26 May 2015

DA 1031/15 - Proposed Subdivision at Lot 198 DP 1191172, Lot 98 DP 1165173, 1452 Solitary Islands Way, Sandy Beach
Response to Council's Request for Additional Information

AV Jennings Properties Ltd
Stages 3-6, Sandy Beach Subdivision
Stormwater Management Report

| | | | | | | | | | Approved (Project Director) | | | | Title PROPOSED STAGING PLAN | | | | |

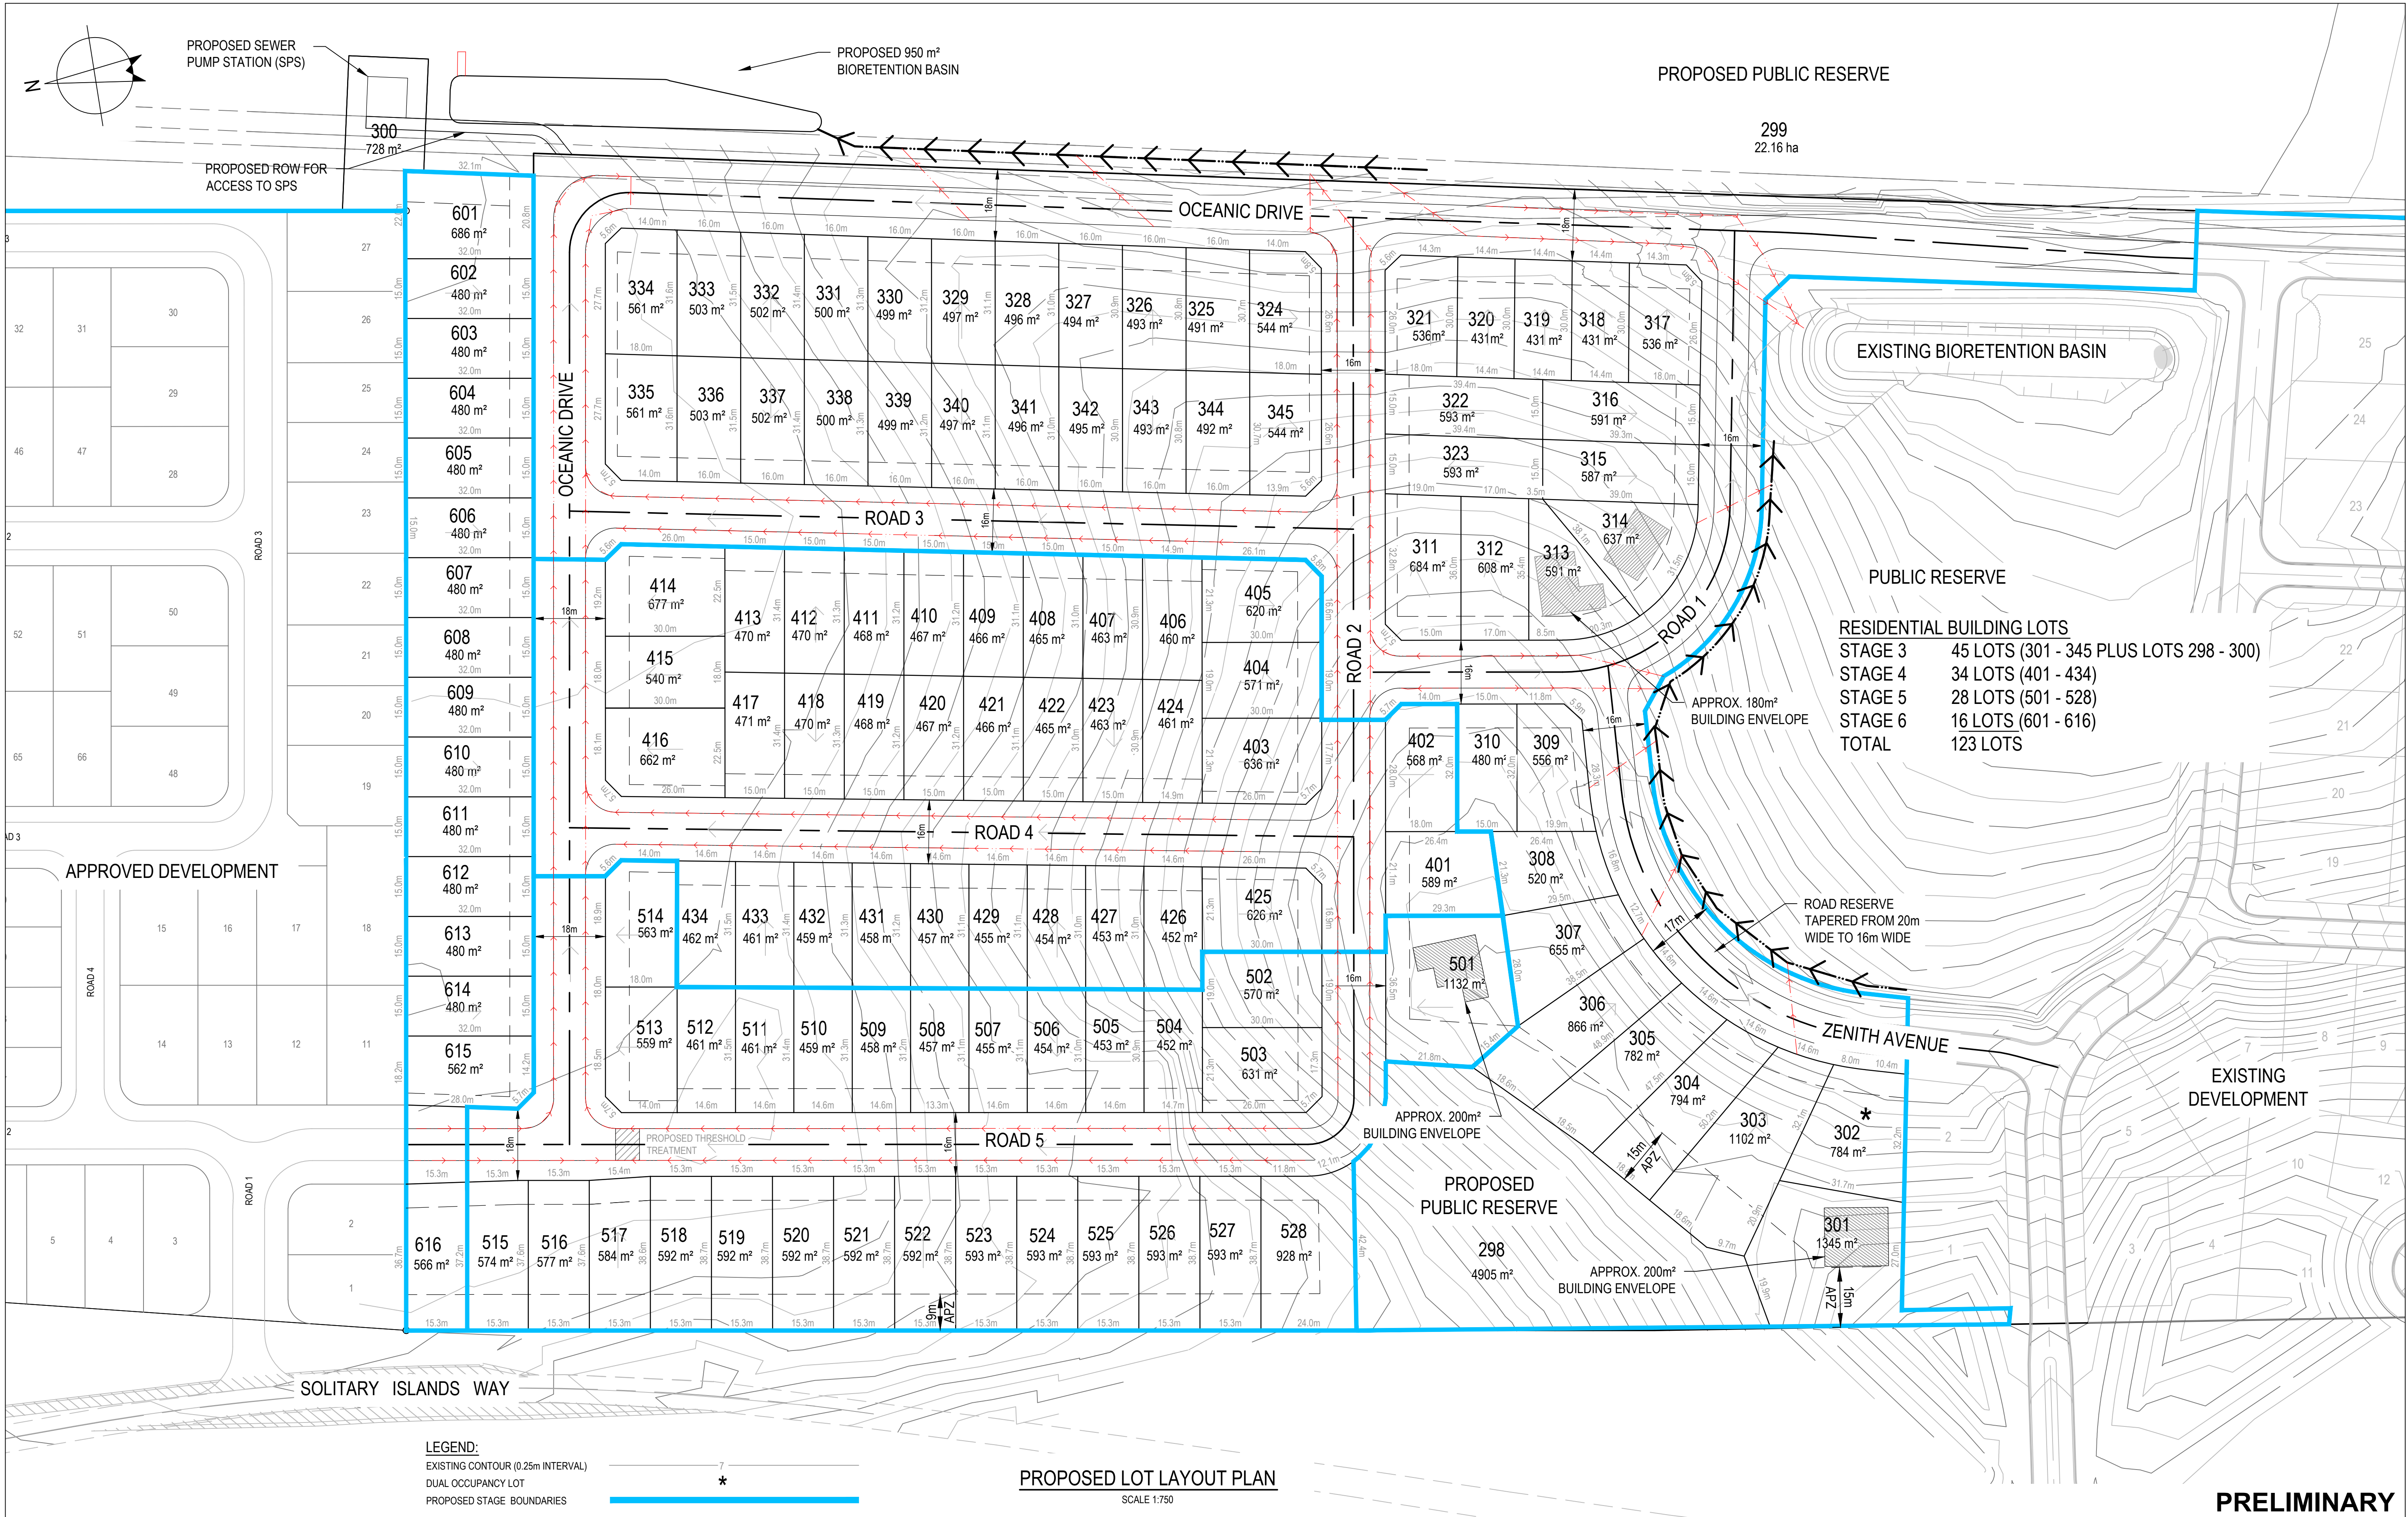
A revised lot layout has been prepared and a total of 123 lots are now proposed within four (4) separate stages as follows:

- Stage 3 – 45 lots
- Stage 4 – 34 lots
- Stage 5 – 28 lots
- Stage 6 – 16 lots

The proposed lots range in size from 452m² to 1,345m².

A copy of the revised subdivision plan is attached to this letter.

|  230 Harbour Drive Coffs Harbour NSW 2450 Australia T 61 2 6650 5600 F 61 2 6650 5601 E cfsmail@ghd.com W www.ghd.com | DO NOT SCALE | | Drawn I. GOULD | Designer S. DOUGLAS | Client | AV JENNINGS PTY LTD SANDY BEACH SUBDIVISION STAGE 3 PROPOSED STORMWATER MANAGEMENT PLAN |

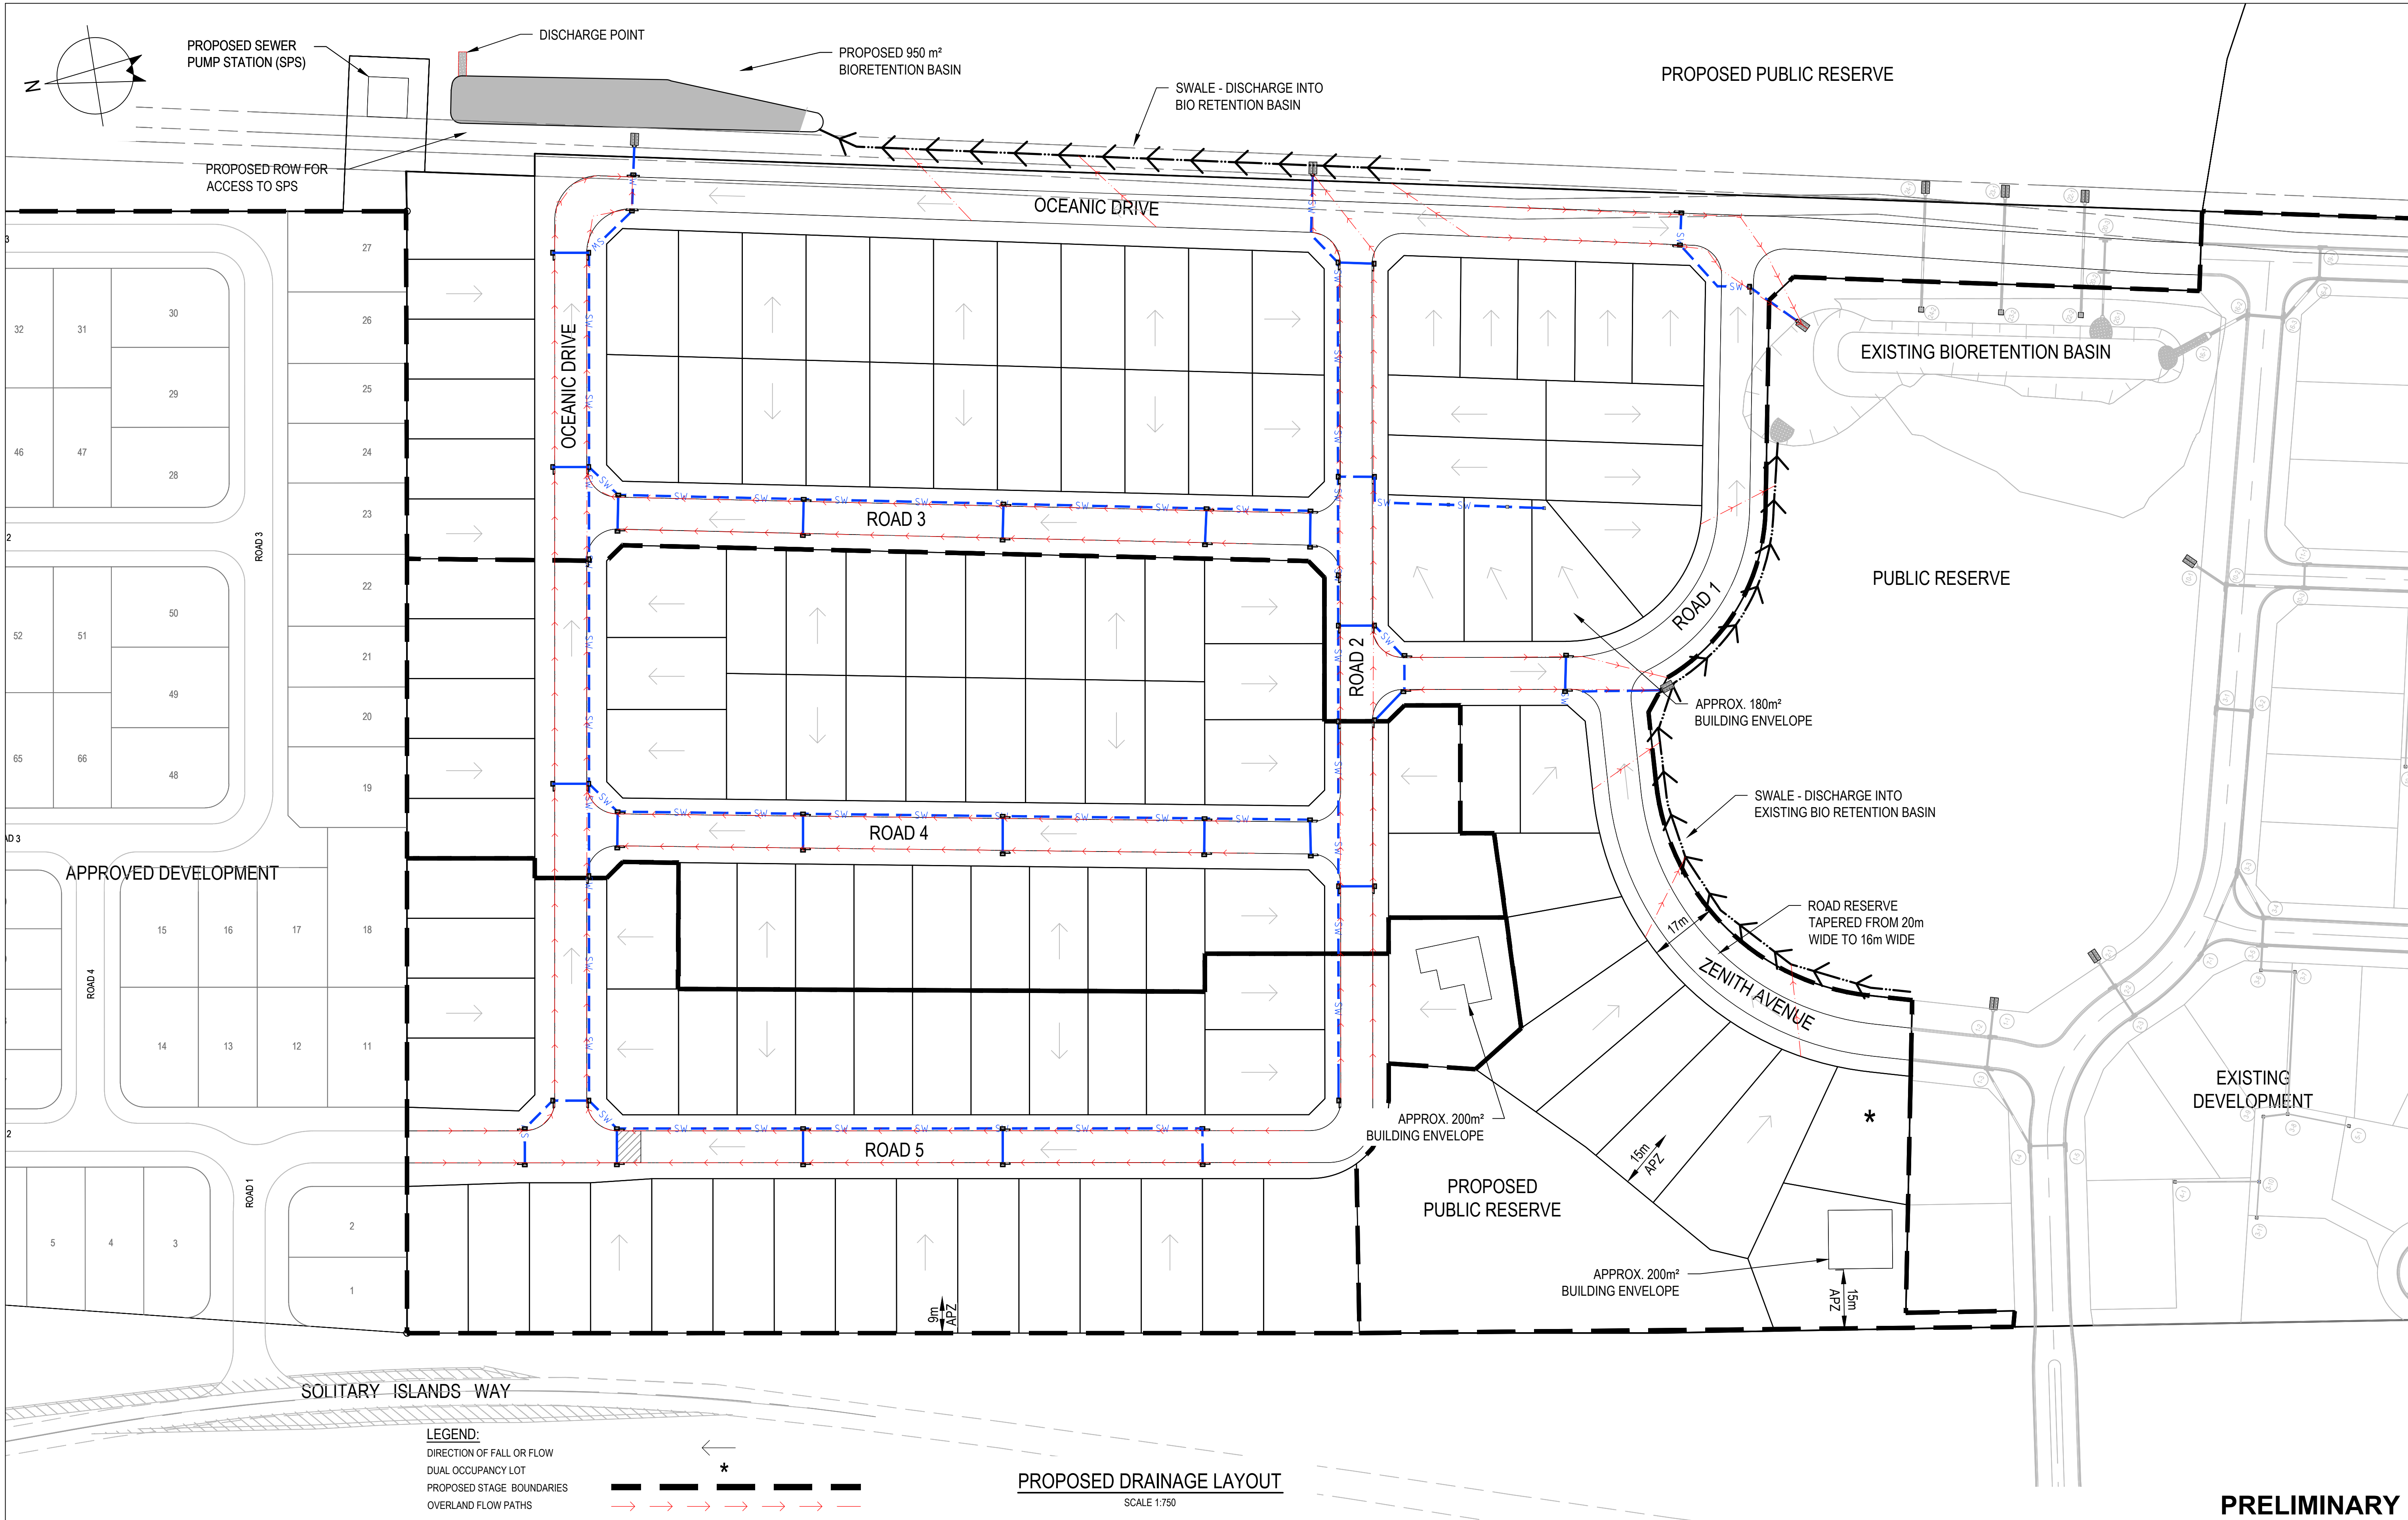
A revised stormwater management plan has been prepared for the subdivision and is attached.

- The revised stormwater management strategy includes the following:
 - A modification to the existing bio retention basin to the north of Stages 1 and 2. Low flows from the northern end of the development (Area C) will be directed through the bio retention basin prior to discharge from the site.

- A proposed new swale running parallel to Oceanic Drive and grading towards a new bio retention basin to the north-east. Low flows from the central area of the development (Area B) will be directed through the bio retention basin prior to discharge from site.

- A proposed new swale running parallel to Zenith Avenue and Road No. 1 surrounding the northern extent of the park area. This swale will collect runoff from the road and lots on the higher, western end of the development (Area A), and discharge flows through the existing bio retention basin.
